Application for Works Approval Amendment

Works Approval Number	W6831/2023/1
Works Approval Holder	Image Resources NL
ACN	063 977 579
File Number	APP-0026275
Premises	Atlas Project Munbinea Road NAMBUNG WA 6521 Legal description – Part of mining tenement M 70/1305 As defined by the premises maps attached to the revised works approval
Date of Report	24/03/2025
Decision	Revised works approval granted

Works approval W6831/2023/1 is held by Image Resources NL (the works approval holder) for the Atlas Project (the Premises), located at Munbinea Road, Nambung.

Figure 1: Noise sensitive receptors around the Atlas Project prescribed premises

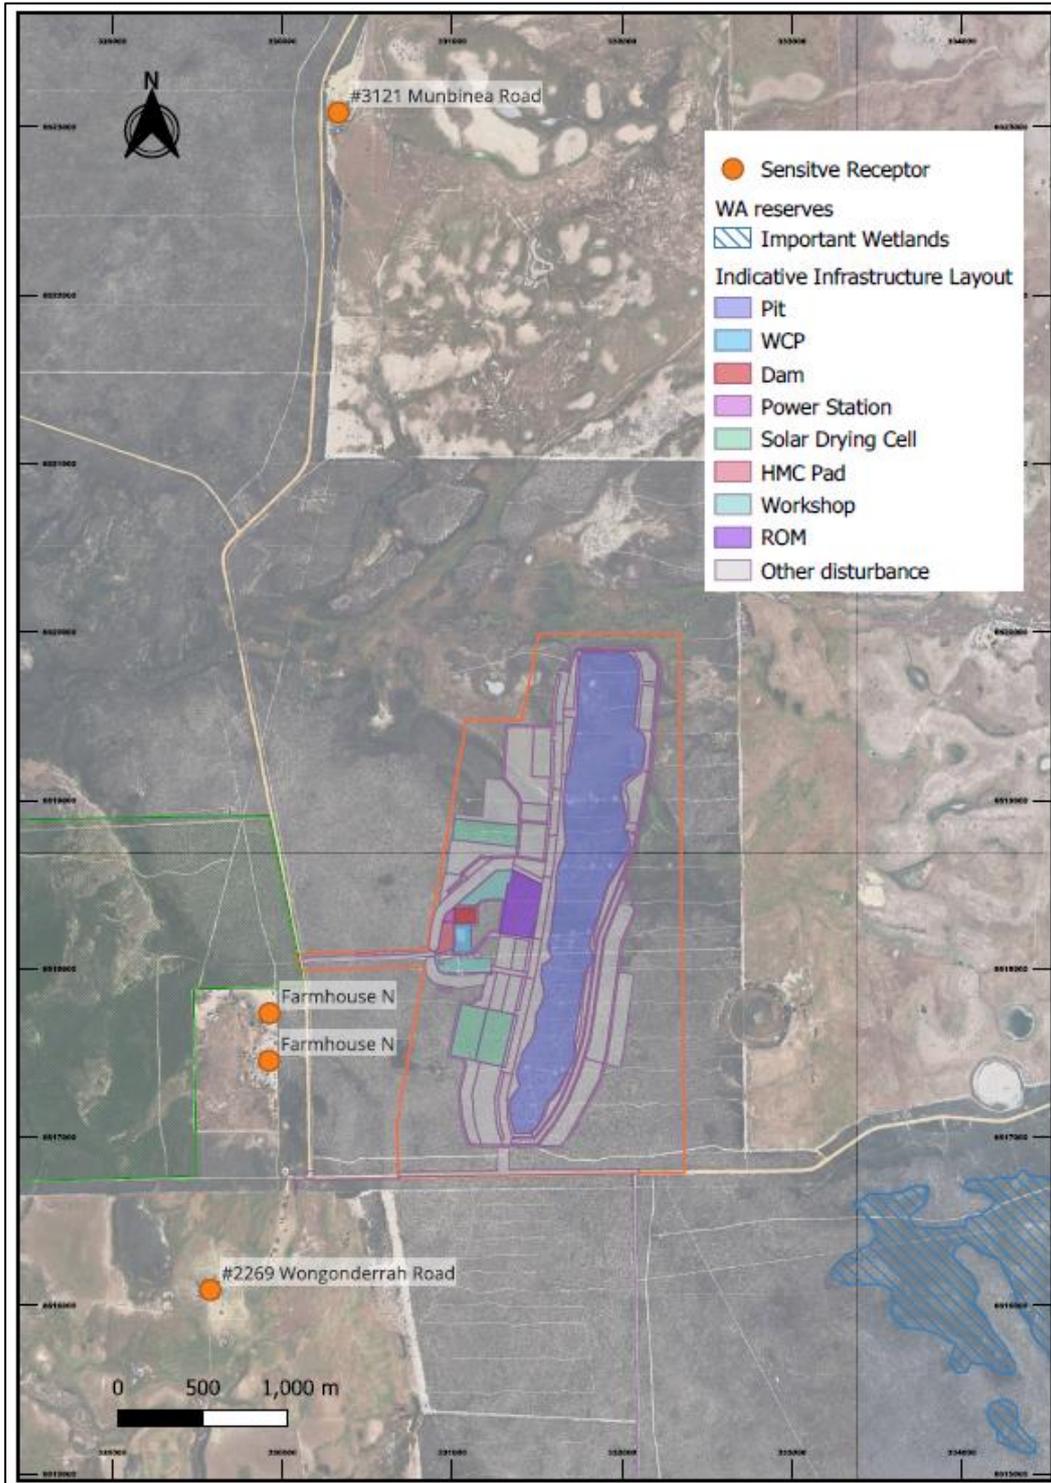
The existing works approval identified four potential noise sensitive receptors within 4 km of the premises (refer to Figure 1). The works approval holder is seeking to remove some conditions relating to noise management and monitoring from the existing works approval, on the basis that the receptors are either sufficiently distanced from the mining operations to be compliant with assigned levels in the *Environmental Protection (Noise) Regulations 1997* (Noise Regulations), or agreements have been entered into which mean that the properties are no longer defined as sensitive receptors for the purposes of the Noise Regulations.

entered into a lease agreement with the property owners of 3700 and 3672 Munbinea Road (labelled Farmhouses N, above) until 1 October 2026, with the provision that the properties will remain unoccupied for the duration of the lease. As there will be no one residing at these properties, the department agrees that, under these conditions, these properties do not constitute a noise sensitive receptor for the duration of the lease.

This leaves only 2269 Wongonderrah Road as a noise sensitive premises that may potentially be impacted by noise levels from the operation. It is understood that the works approval holder has purchased the property at 2269 Wongonderrah Road and has leased it back to the former owners through an Occupancy Deed. The property includes a house as well as an active caravan park business. The Nambung Station Stay and Caravan Park, located on 2269 Wongonderrah Road, holds a current license issued under the *Caravan Parks and Camping Grounds Act 1995*. As such, both the caravan park and the residential dwelling at 2269 Wongonderrah Road continue to meet the definition of a noise sensitive premises for the purpose of the Noise Regulations, and the relevant assigned levels must be met at this location.

Figure 2: Depiction of mining areas used for noise modelling scenarios in LGA (2025)

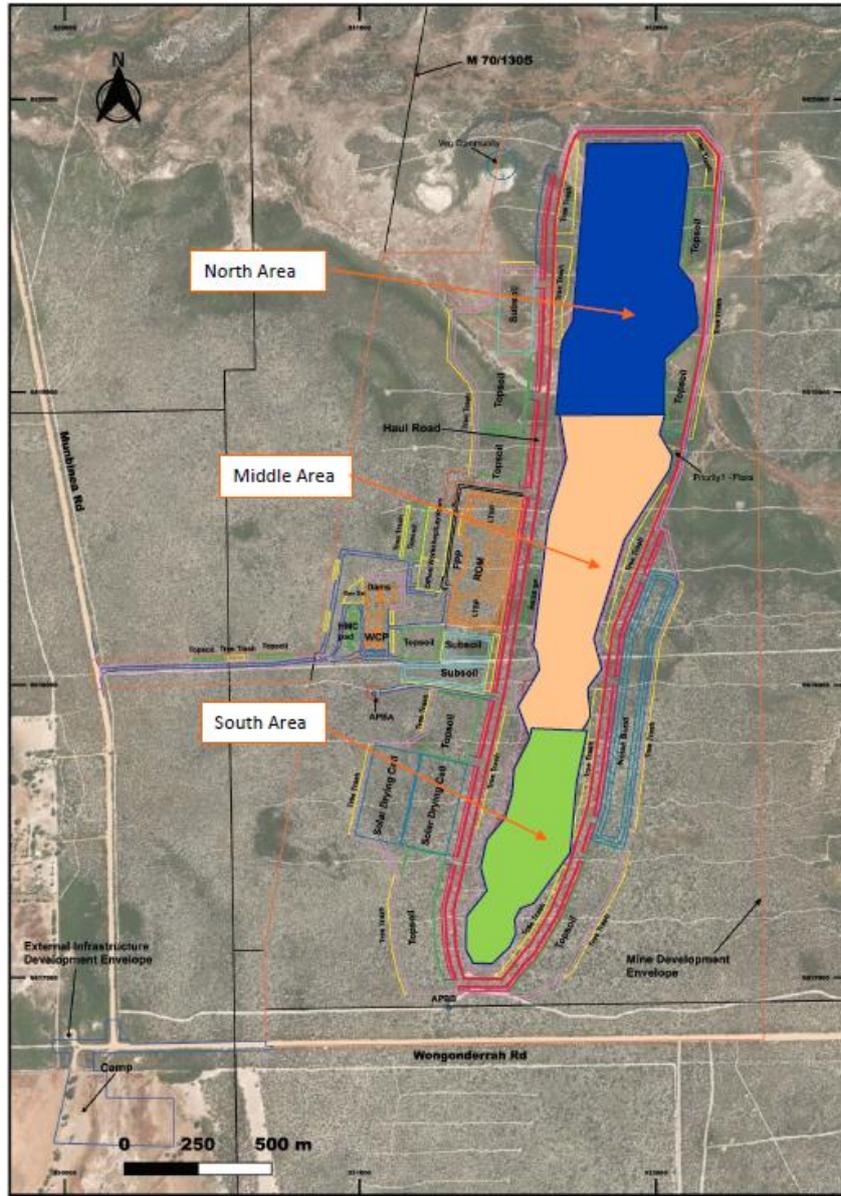
The revised modelling divides the pit into three distinct zones that were modelled independently (refer to Figure 2). The revised modelling indicated that, at the Wongonderrah Road property, the nighttime assigned noise levels (35 dB) will comfortably be met when mining activities occur in the "north area" of the pit. Furthermore, it shows that the evening and Sunday assigned noise levels (40 dB) (but not the nighttime assigned levels) will be met at this property when mining activities in the "south" and "middle" areas of the pit.

The department agrees that it is appropriate to modify the conditions on the works approval to reflect the refined noise modelling results. This will allow for mining at any time of day in the north of the pit, and an expansion of mining hours in the evenings and on Sundays in the middle and southern areas of the pit.
